UNITED STATES PATENT AND TRADEMARK OFFICE

10/814,132

Office Action Summary	Application No. 10/814,132	Applicant(s) KIYOTA, HIROTAKA 	
	Examiner Javaid Nasri	Art Unit 2839

DETAILED ACTION

FIG. 3A

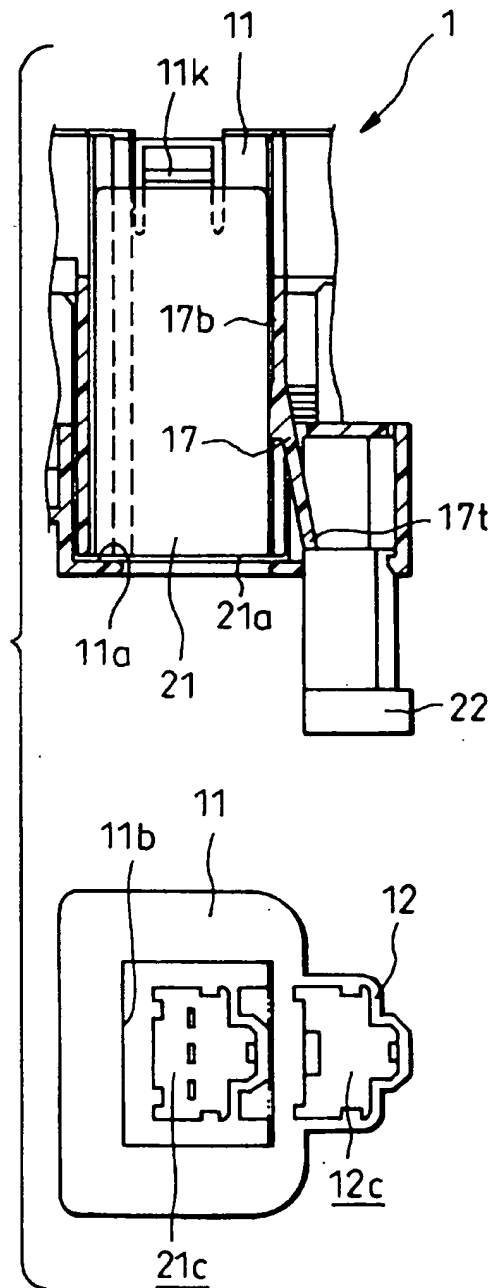
Higashida et al discloses, **for claim 1**, a box body; a provisionally-attaching portion (12) for provisionally attaching a first connector (22) connected to a wire harness to the box body provided to the box body (see figure 3A); and a circuit unit (21) including a second connector (21c) adapted to be mounted on the box body, wherein when the circuit unit (21) is mounted to the box body, the first connector (22) is detached from the provisionally-attaching portion (12) and is connected to the second connector (21c) (see figure 3B, see col. 7, lines 43-51), **for claim 2**, the provisionally-attaching portion is formed on a wall portion of the box body forming a receiving space for receiving the circuit unit, and when the circuit unit is received in the receiving space, the provisionally-attaching portion is disposed between the wall portion and the circuit unit (see figure 1), **for claim 3**, the provisionally-attaching portion including a guide rib which is formed on the wall portion and extends in a direction in which the first connector (22) is inserted (see figure 3A), and the first connector (22) includes a guide groove for sliding engagement with the guide rib (see marked figure 3B, attached), **for claim 4**, the provisionally-attaching portion includes a pair of side ribs provided at opposite sides of the guide rib, respectively, and the first connector includes a pair of side guides for engagement respectively with the pair of side ribs (see marked figure 3B, attached).
